# CONNECTION ASSESSMENT & APPROVAL PROCESS

*Project: Temporary Relocation of Transformer T2 from Froid  
Stobie No. 2 Substation to INCO No. 4 Substation to  
replace the faulted Transformer T1*

***CAA ID No. 2003-EX177***

*Date: 12th December 2003*

**DIAGRAM 1**

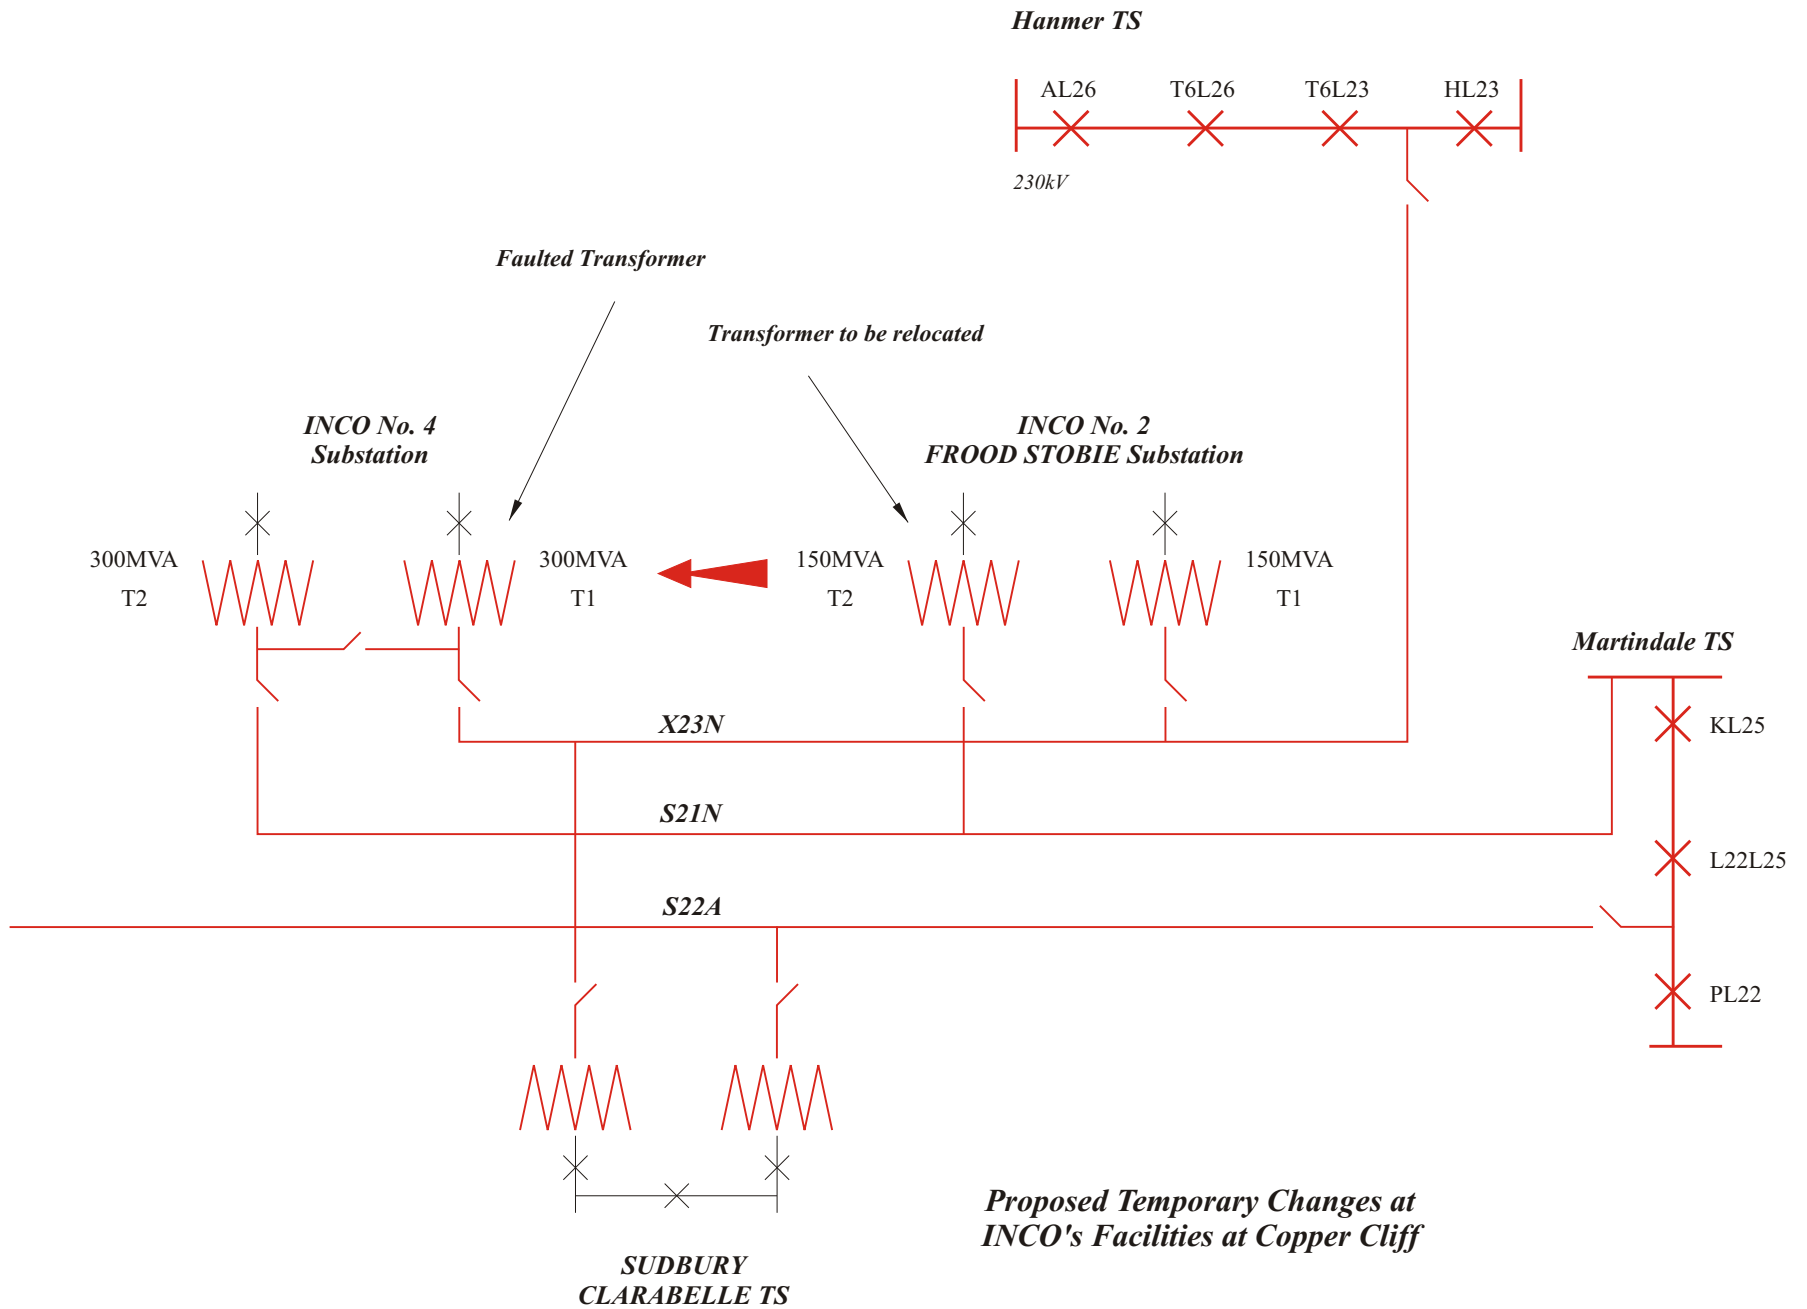
With the removal of transformer T2 [230FS2T2] from the Frood Stobie Substation, all of the load at this Substation will be supplied from circuit X23N.

Similarly, with transformer T1 [230CC4T1] at INCO Copper Cliff No. 4 Substation energised, but off-load, all of the load at this substation will be supplied from circuit S21N.

Apart from the change in loading on circuits S21N & X23N this temporary arrangement is expected to have no adverse impact on the IMO-controlled grid.

It is therefore recommended that a Notification of Approval of the Connection Proposal be issued.
